Project: **Platte Self Storage** Location: **Drive Aisles S1 in Basins 3A-3E**
 By: **John F** Date: **11/6/2024**
 Chk By: _____ Date: _____ version 12-2004

PLATTE SELF STORAGE

SITE DEVELOPMENT PLAN

Figure 8-11. Inlet Capacity Chart Sump Conditions , Curb Opening (Type R) Inlet

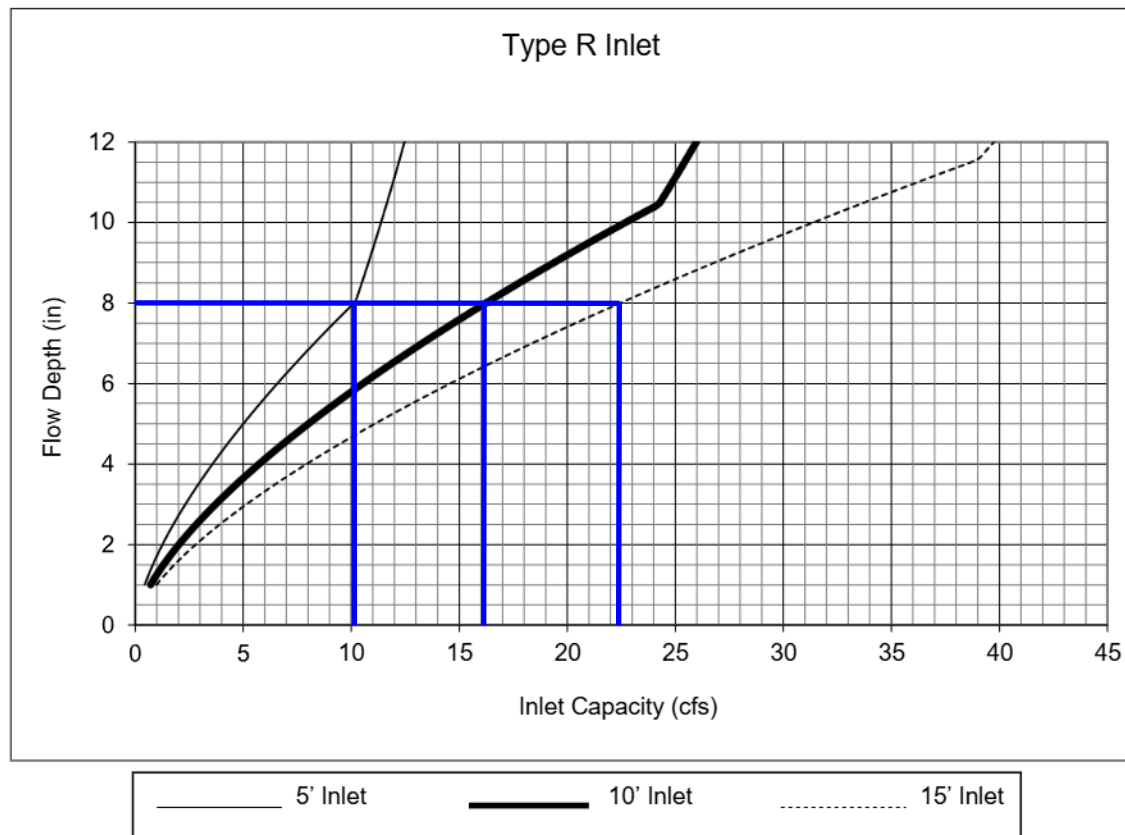
Unresolved:

MHFD Inlet spreadsheet has all inlet types available. Please use that spreadsheet for inlet design of Type R and C inlets .

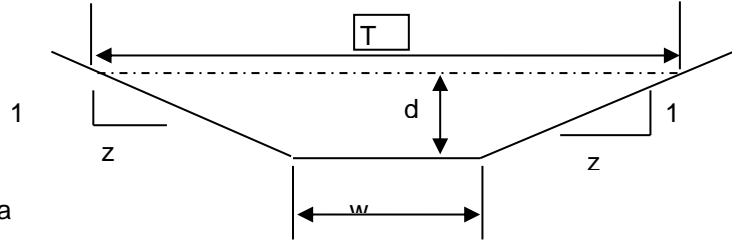
Please include back into report design sheet for the swale in the Central Drive Aisle which was in the last submittal.

Which PR-3 Basin? Basins are labeled as PR-3A thru PR-3E.

TNES Response:
 Referenced calculation has been removed and replaced with the calculation on the following sheet. Calculation was not added back in.

Project: **Platte Self Storage** Location: **Swale S3 in Basin OS-W**
 By: **John F** Date: **11/6/2024**
 Chk By: _____ Date: _____ version 12-2004

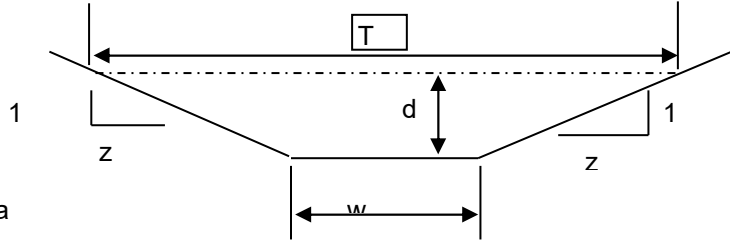
Provide a more specific design as it appears velocity could be over allowable.

Figure 13-12c. Emergency Spillway Protection

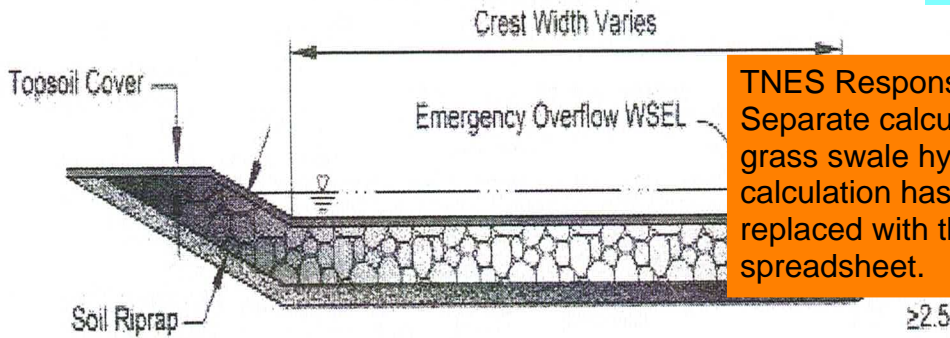
Drainage Map has this swale called out as grass. Please verify and update accordingly as to if it is riprap or grass.

How was length and width determined?

This graph is for the overflow spillways at a pond. Suggest using a riprap rundown spreadsheet instead of this one.

TNES Response:
Separate calculation provided for grass swale hydraulics. This calculation has been removed and replaced with the Rock Chute Design spreadsheet.

Pipe ID: **18" RCP Culvert**

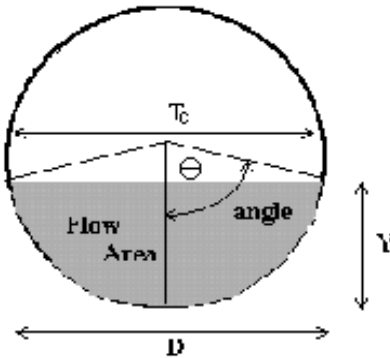
Include label to indicate which culvert this is.

Basin ID: **18" RCP Culvert**

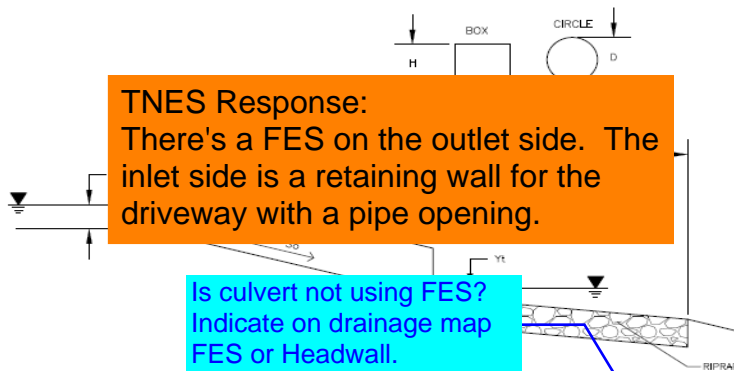
Is culvert not using FES? Indicate on drainage map FES or Headwall.

Indicate what is being done for supercritical condition. Per criteria, FR # needs to be less than 0.9.

TNES Response:
There's a FES on the outlet side. The inlet side is a retaining wall for the driveway with a pipe opening.

TNES Response:

1. I can't find anything in the County standards that say culverts have a required froude number.
2. This is a culvert spreadsheet. The froude number shown is for the pipe. The spreadsheet doesn't include any inputs for the outfall or swale (which is where the County standards do talk about froude numbers).
3. In answer to your comment: nothing is being done about the supercritical condition in a concrete pipe, beyond it being inside a concrete pipe. There is a FES and riprap pad after the concrete pipe that would have very different input values.

Note: The only way we found to get this froude number below 0.9 was to use CMP so it had a much higher n value. Putting CMP under a driveway that's going to have heavy truck traffic isn't a good idea.

EXISTING DRAINAGE MAP

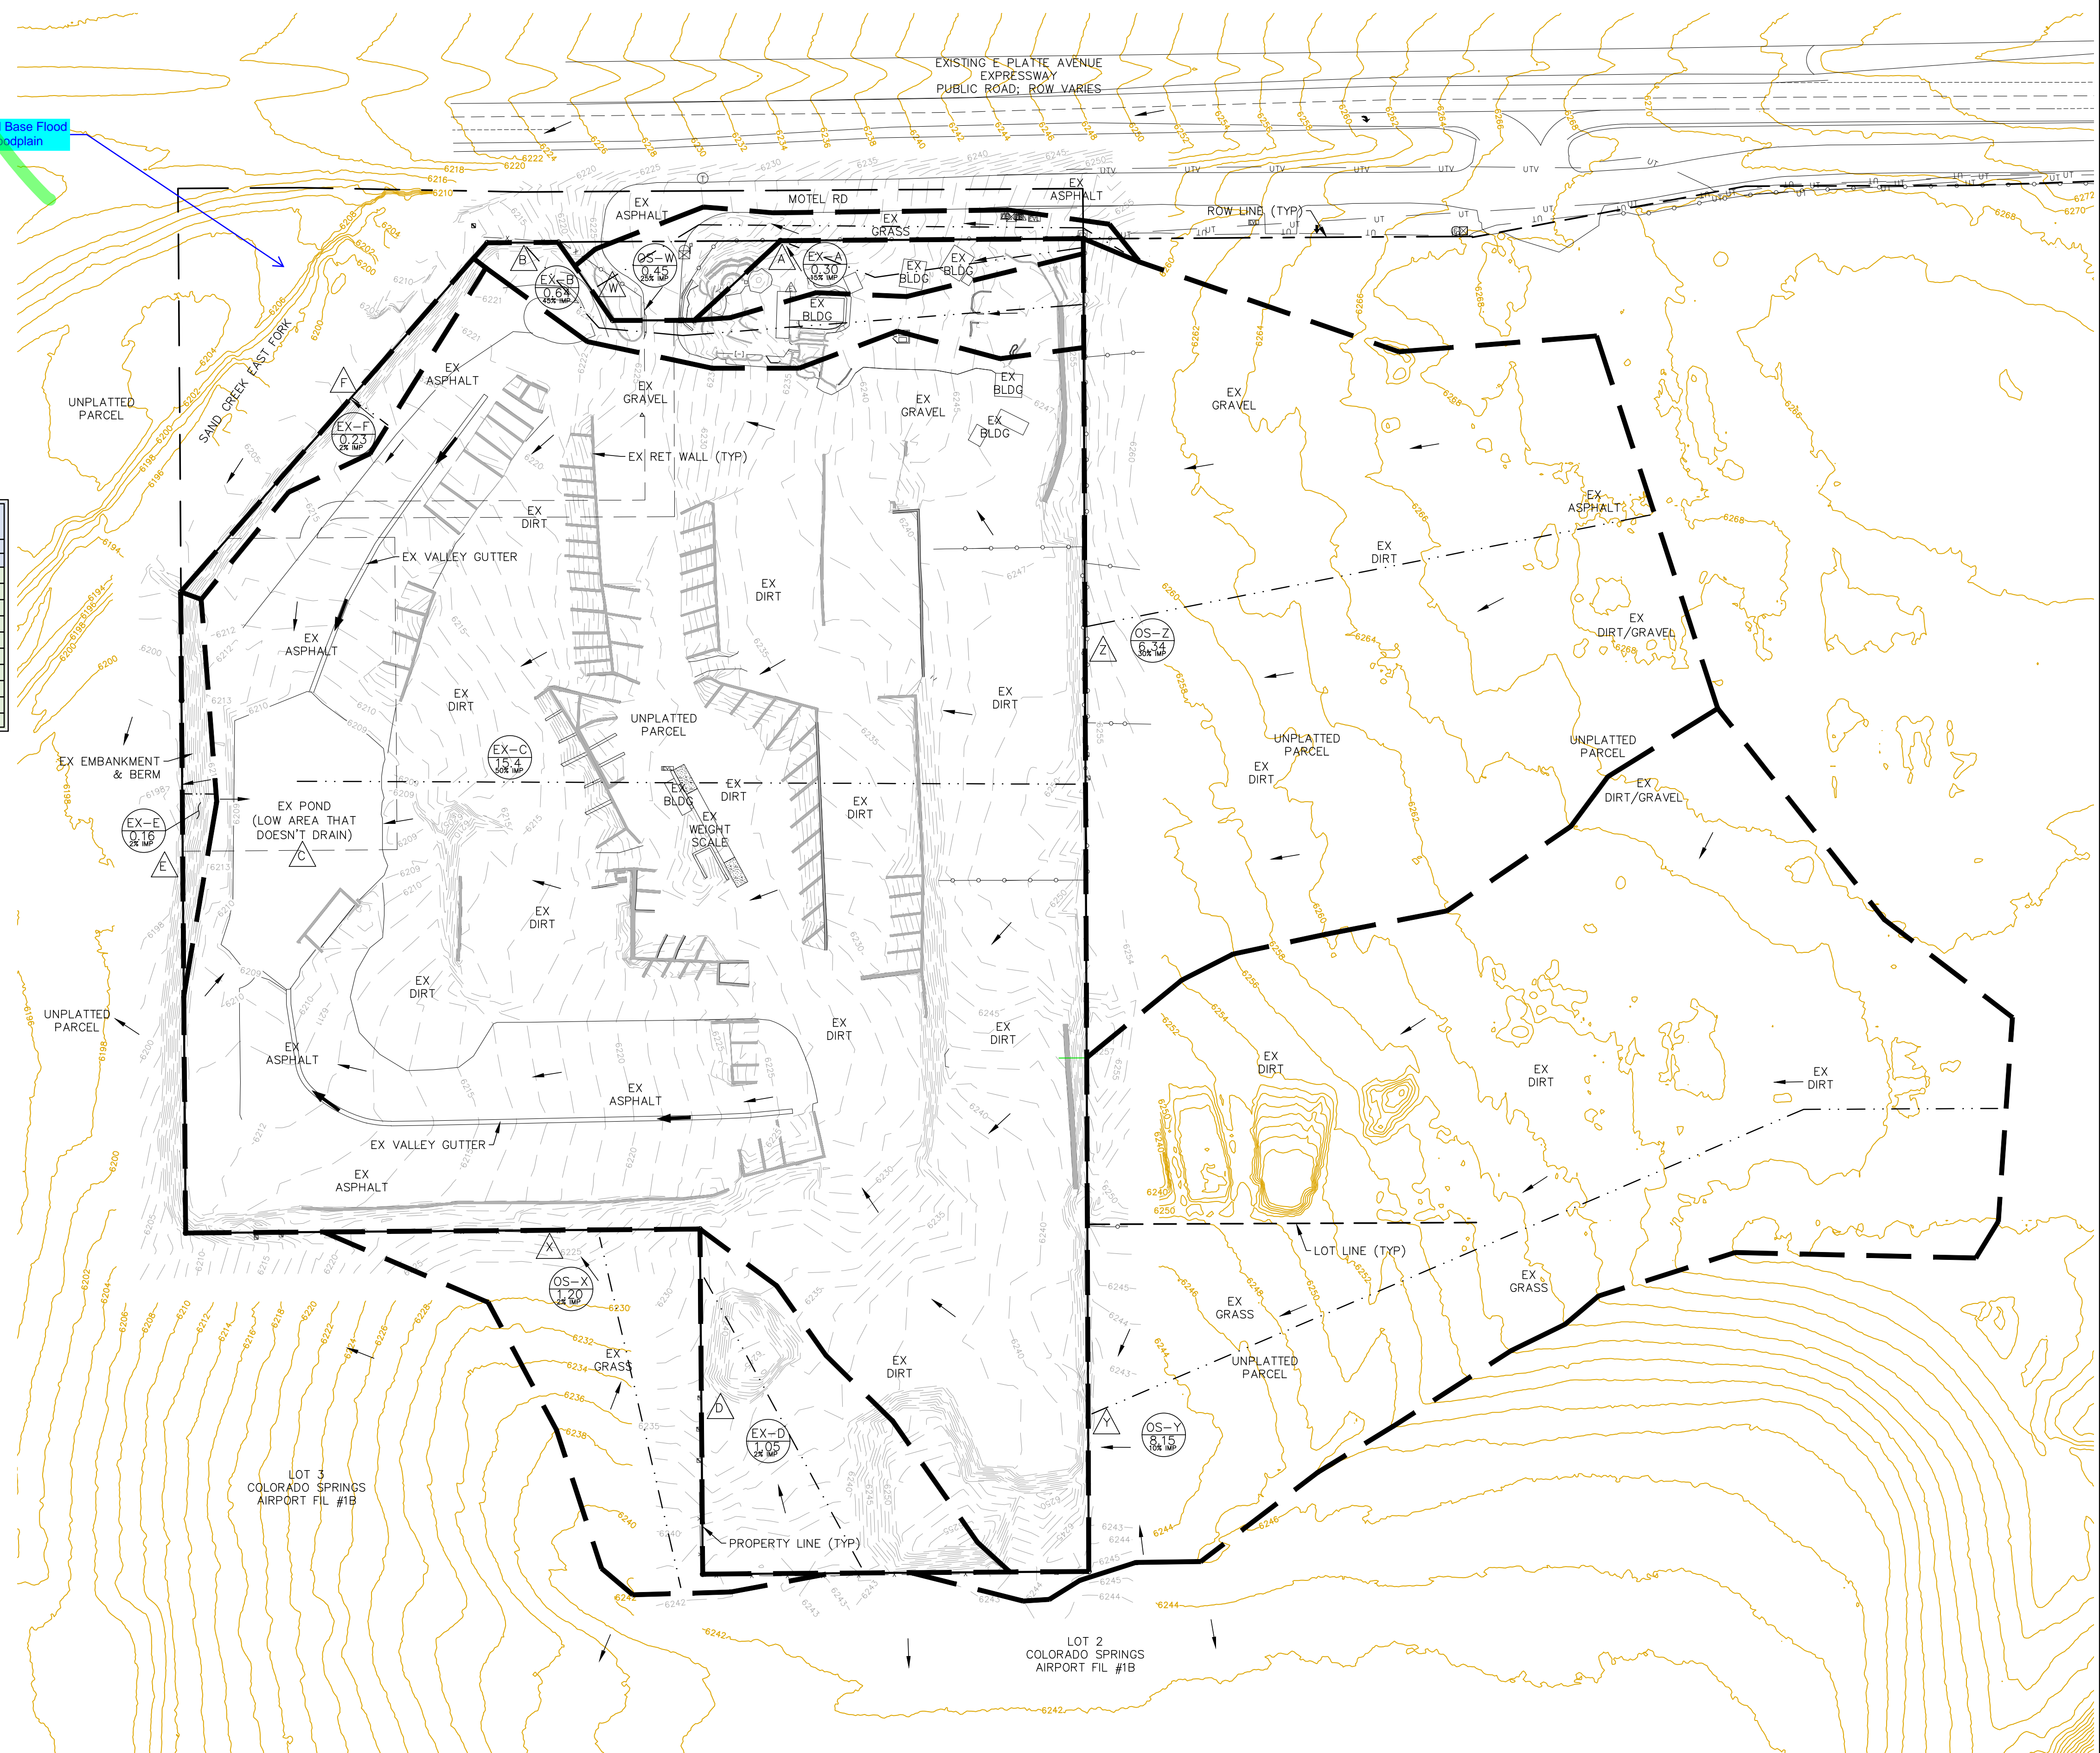
Show and List Base Flood Elevations in Floodplain
